PROPOSED PILECAP & PILE POSITIONS

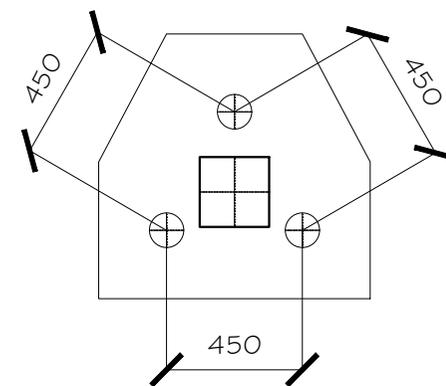
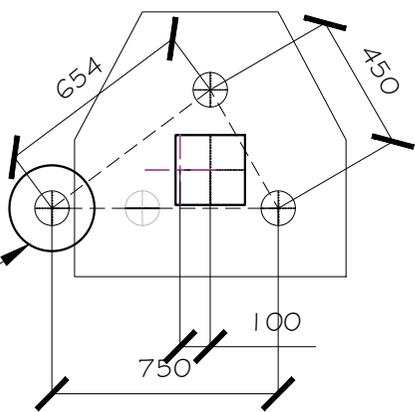
NEW LOCATION OF THE PILE
